Appendix G

G1. Geotechnical and
Geomorphic Assessment
of Permanente Creek
(Golder Associates,
October 21, 2019)

TECHNICAL MEMORANDUM

GEOLOGIC AND GEOMORPHIC ASSESSMENT OF PERMANENTE CREEK, LEHIGH HANSON PERMANENTE QUARRY, SANTA CLARA COUNTY, CA

Figure 6: Profile of Material Removal Area from Station 152+50 to 132+50.

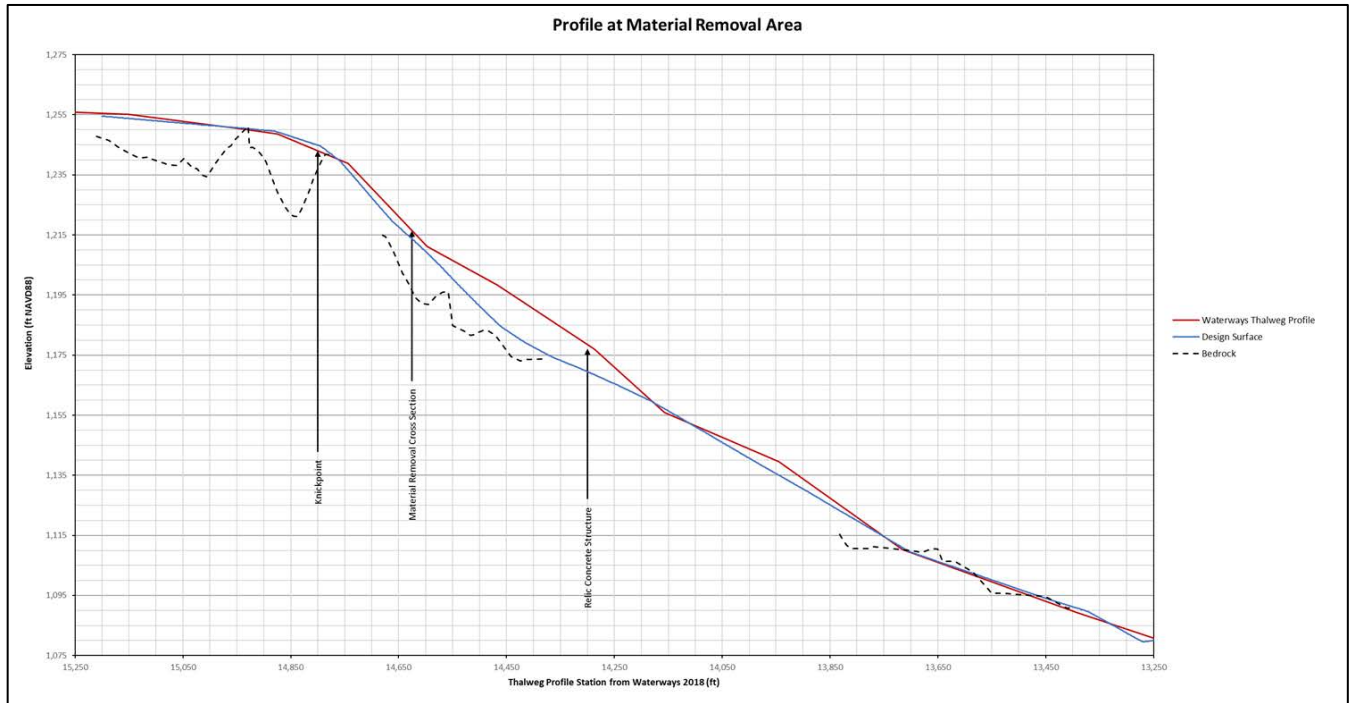
The following bullet points provide Golder's observations of the design as compared to conditions observed in the site reconnaissance and as informed by the seismic refraction survey data.

- Between Stations 146+50 and 142+50, the restoration design identifies a large quantity of material for removal from the channel. The relic mining infrastructure may play a role in defining the channel alignment and facilitating an armored surface on some of the debris. The result of the restoration efforts will increase the local gradient within this reach and extend the length of the high-gradient portion of the channel. Sheet C34 of the 2019 plan set provides additional details for Step-pool and cascade channel design segments in this reach to mitigate the local gradient. We concur with this approach and note that field engineering design modifications and follow on monitoring may be necessary to ensure that the post material removal channel geometry is stable.

Figure 10: Profile of Rock Pile Area from Station 104+50 to 84+50.

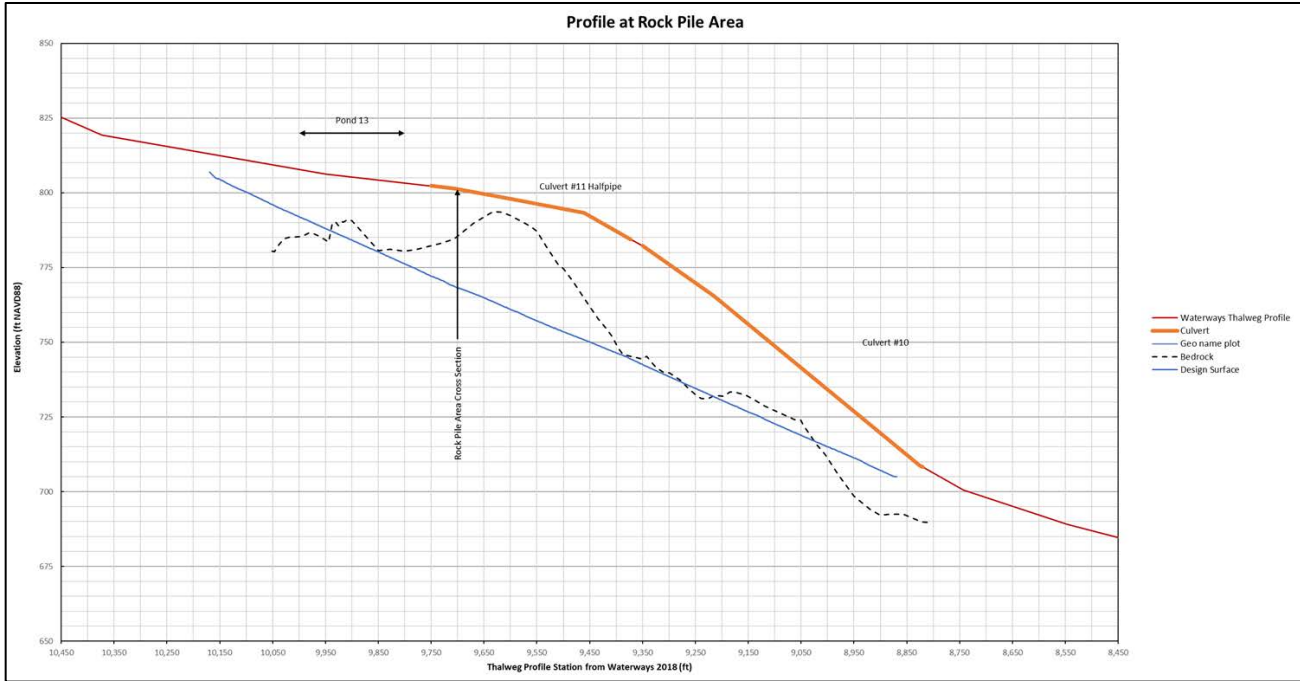
- In the Rock Pile Area, Golder’s comparison of the restoration design with seismic survey results indicates that bedrock ranges from about 5 feet to approximately 25 feet below ground surface with significant relief along the longitudinal profile (Figure 10). As with the Material Removal Area, the design intent will allow for the work to conform to and follow the bedrock surface as it is uncovered during excavation.

- The bedrock surface depicted on Figure 10 is close to the “Upper Limit of Potential Design Channel Invert” as defined by Waterways (based on seismic lines and verification borings), whereas the grading plan included on the design drawings represents the “Lower Limit of Potential Design Channel Invert” to show the maximum extent of potential grading. It is our opinion based on the review of available data that the constructed profile will be close to the “Upper Limit” upstream of Rock Pile Design. In summary, it is our opinion that the design is reasonable, and additional exploration will not provide value to the design above and beyond the data provided by the seismic refraction surveys and previous completed borings.

Figure 11: Cross section at the Rock Pile Area. Located at Thalweg Profile Station 97+00.

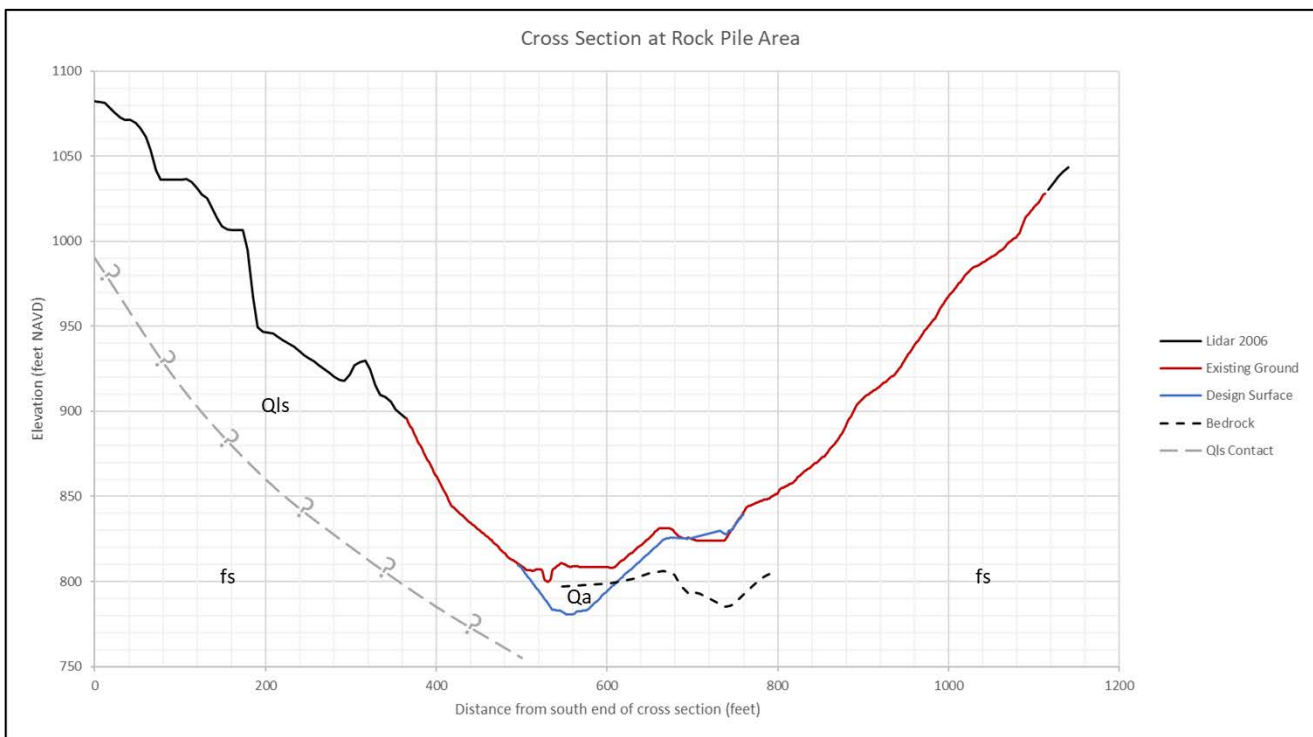
- The seismic data also identifies a potential former bedrock channel, which extends through the Rock Pile Area that in some locations is north of the proposed thalweg (Figure 11). Golder understands that Waterways has, to the extent possible, re-occupied the historic thalweg; however, extensive grading would be required in some areas to realign the channel and move it further to the north to occupy the historic channel thalweg. We understand that pushing the toe of the slope further north is not considered feasible given that this would require significant flattening of the slope which would impact the extensive infrastructure located at the top of slope including the main access road and the crusher facility. Golder recommends that field engineering design modifications be applied to utilize existing

bedrock topography and historic thalweg to the extent possible to meet the desired restoration outcomes.
